REVIEWED FOR CODE COMPLIANCE
KELLY A. JANIS
WEBER COUNTY
BUILDING INSPECTION DEPARTMENT

PONDEROSA
WOLFCREEK - LOT 35

Project Information
3570 N. WILLOW CREEK LANE
EDEN, UT 84310
PINEVIEW VILLAGE LOT 35 - PONDEROSA

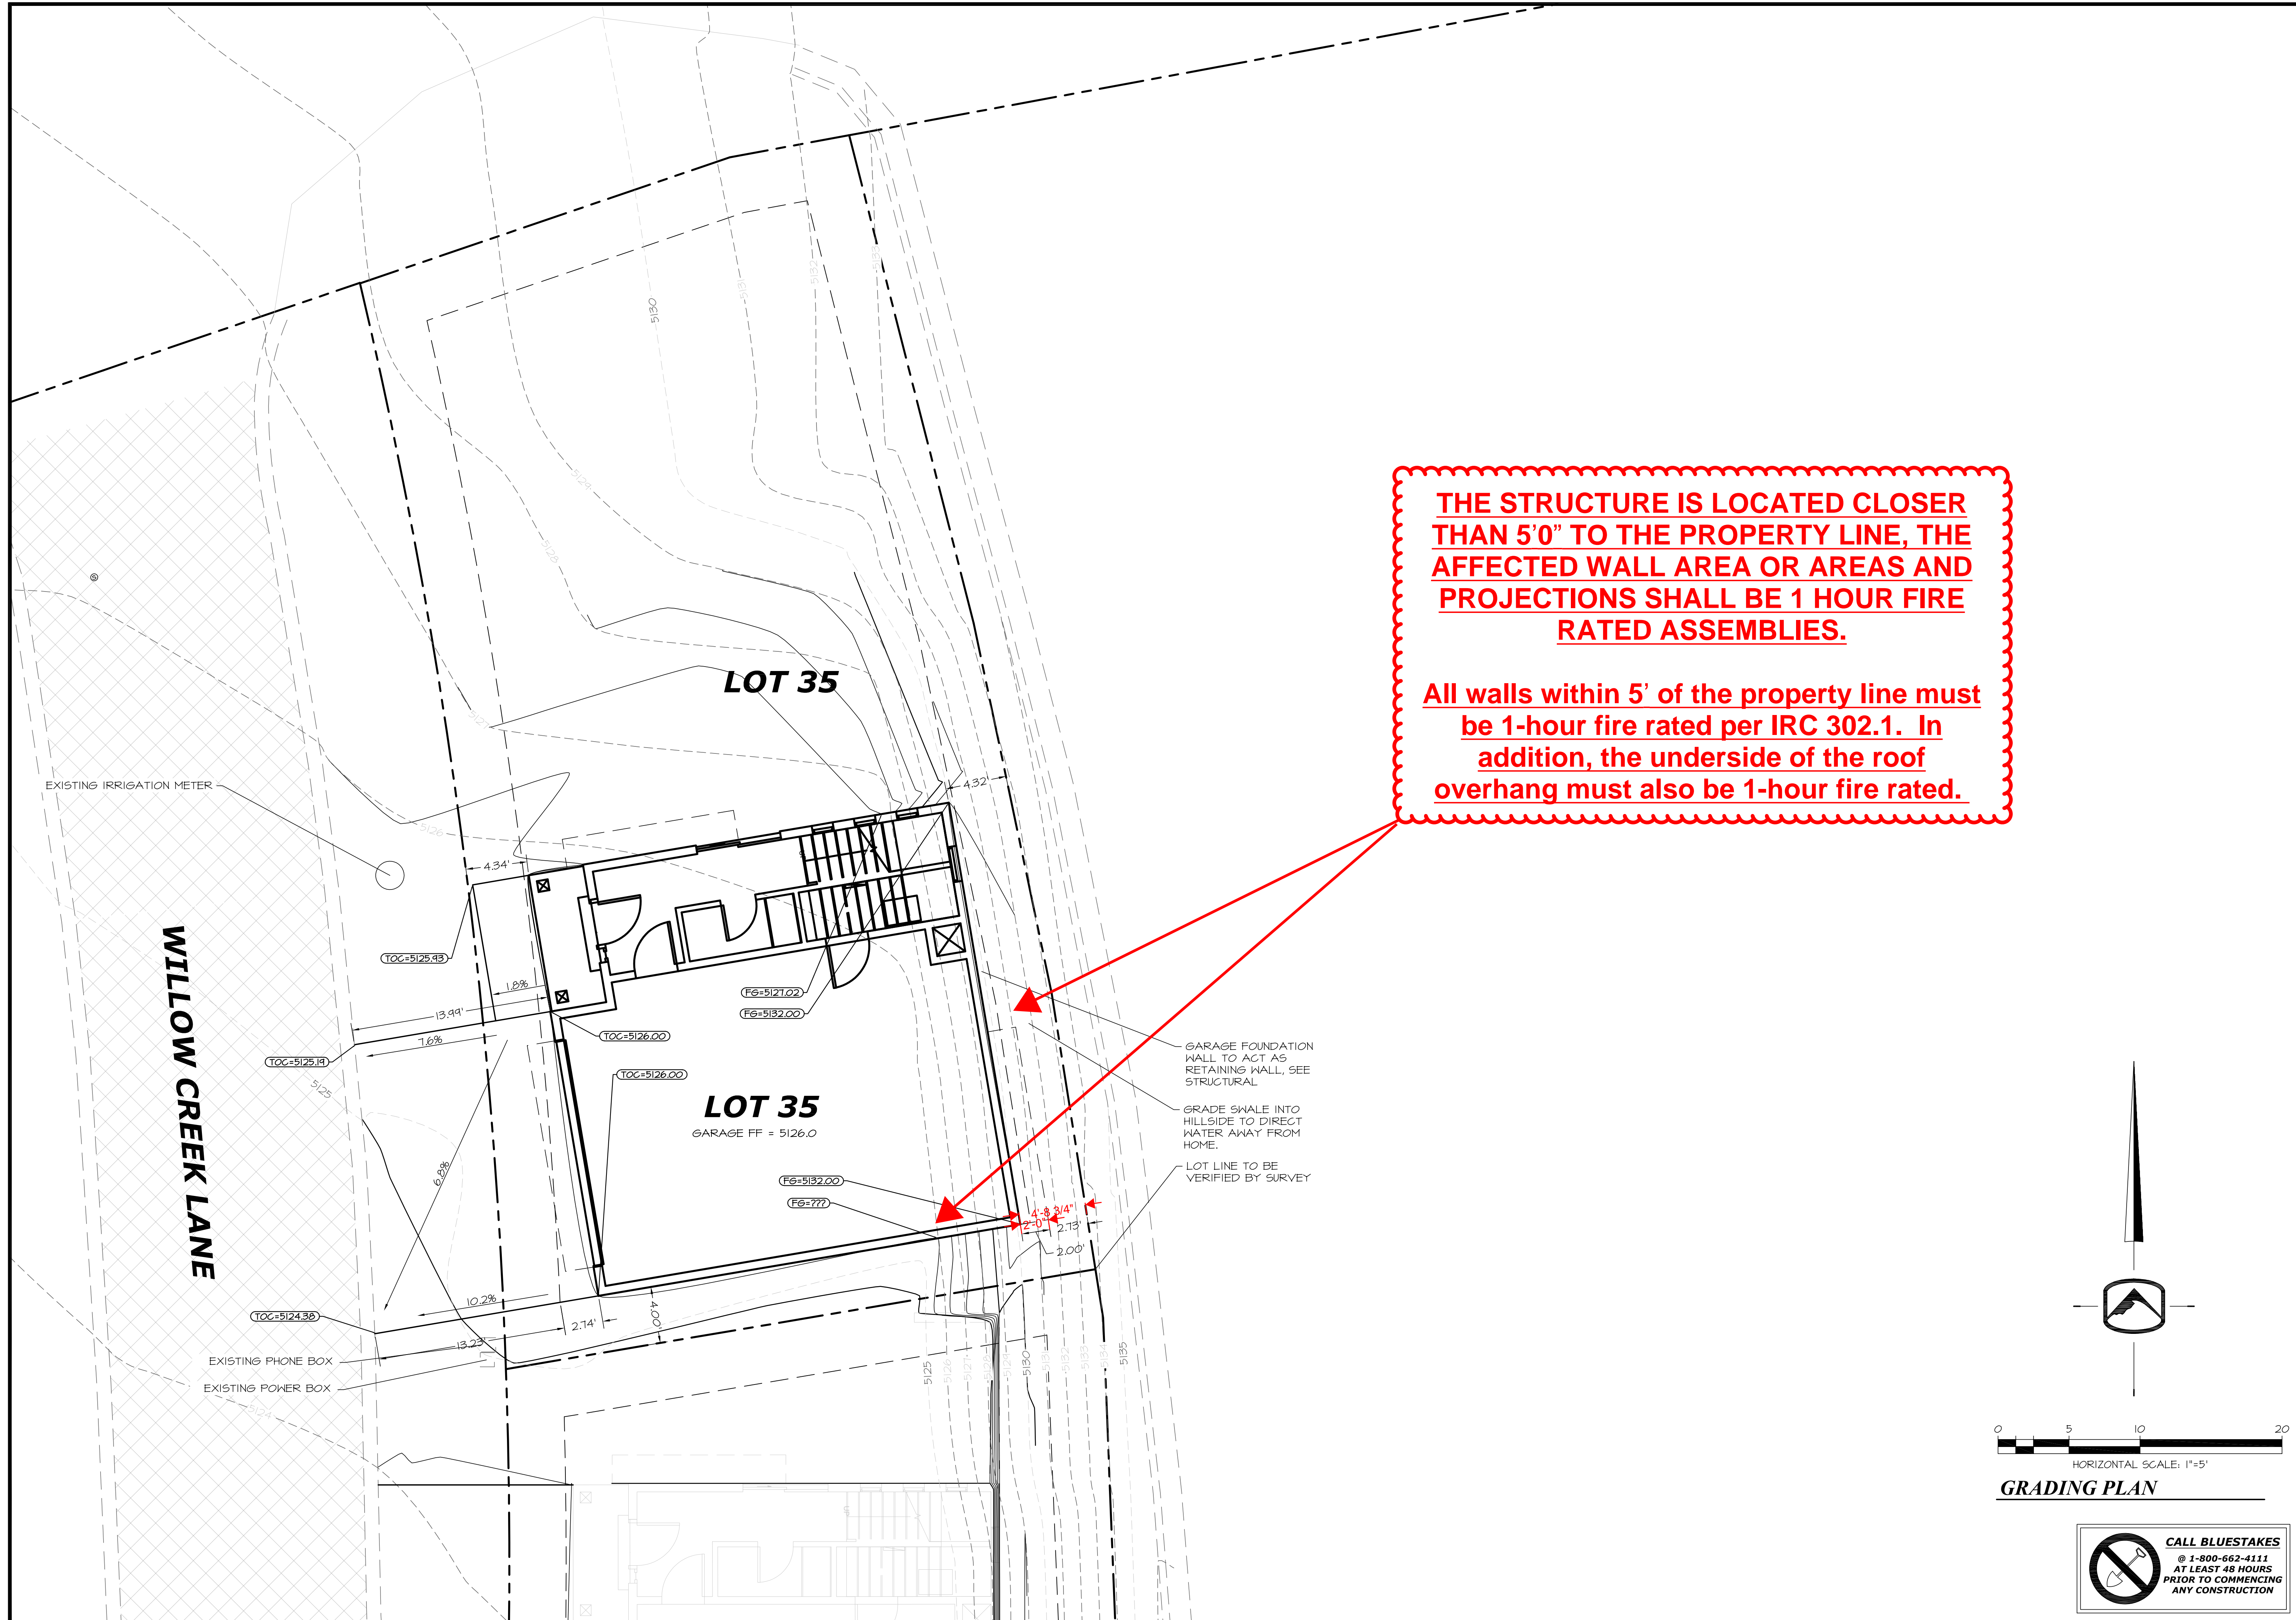
All walls within 5' of the property line must be 1-hour fire rated per IRC 302.1. In addition, the underside of the roof overhang must also be 1-hour fire rated.

SECOND FLOOR

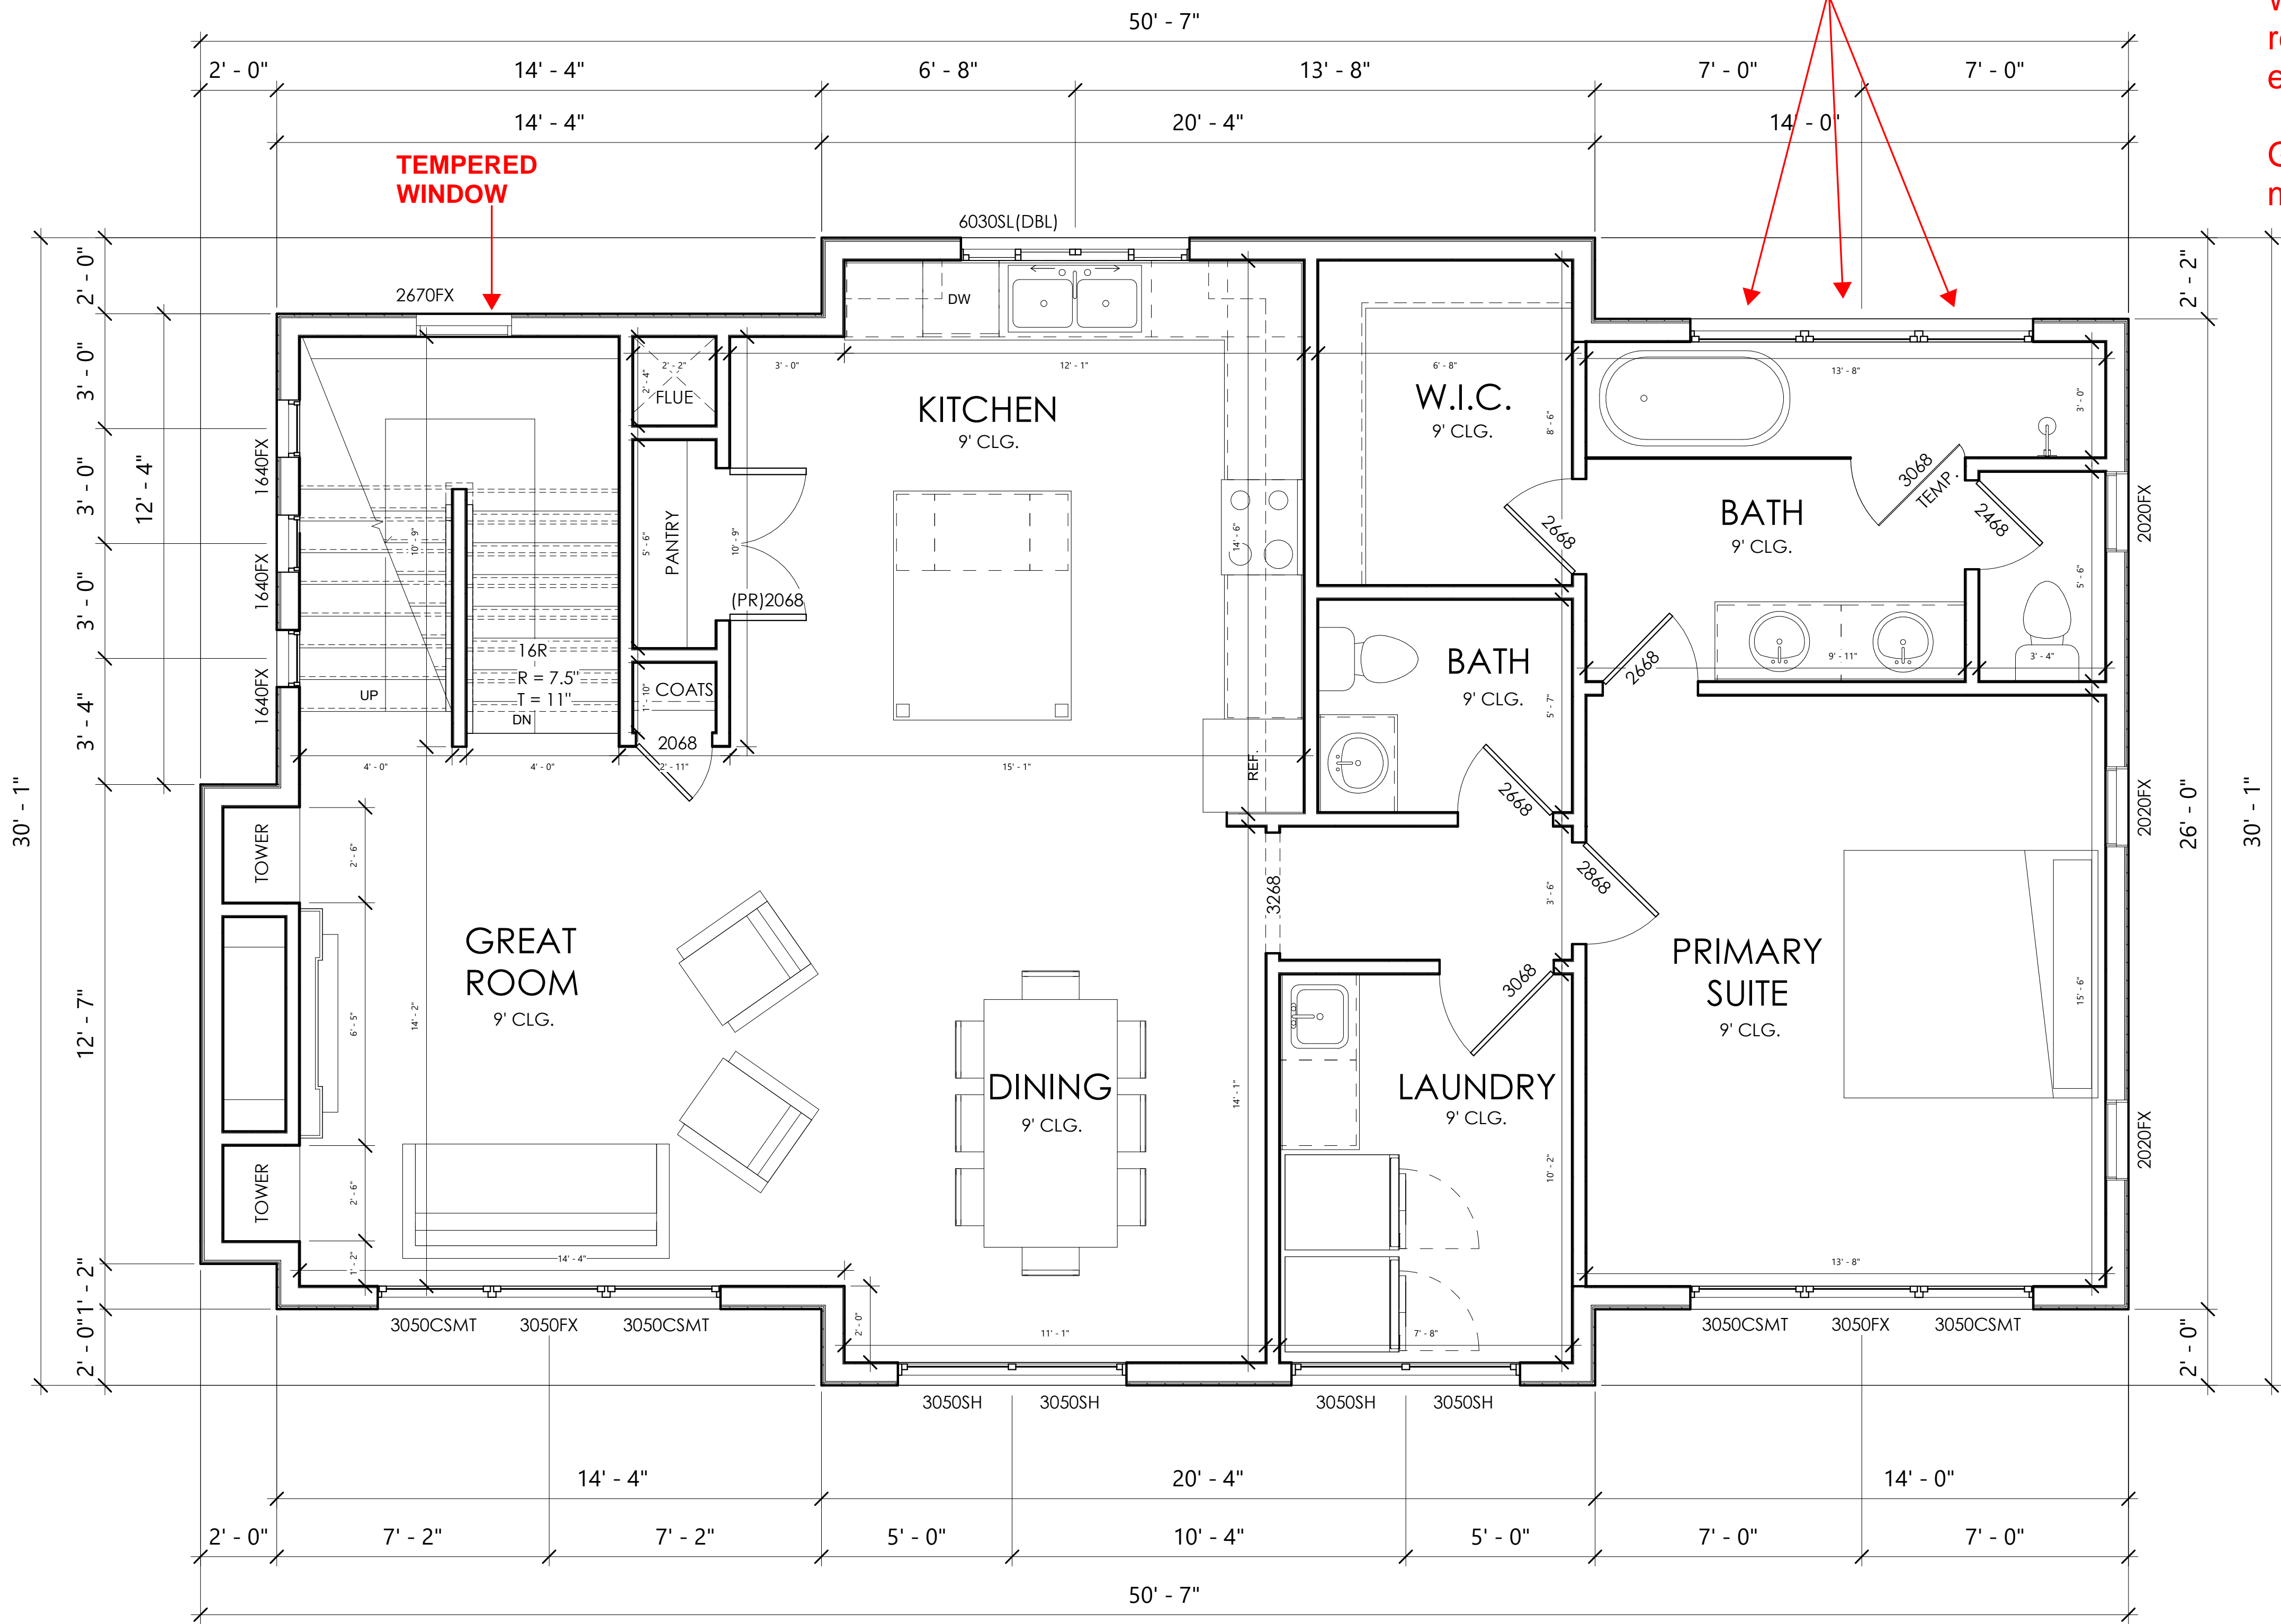
Windows must meet egress requirements and must have egress casement hardware.

Glass shower panels and door must be tempered.
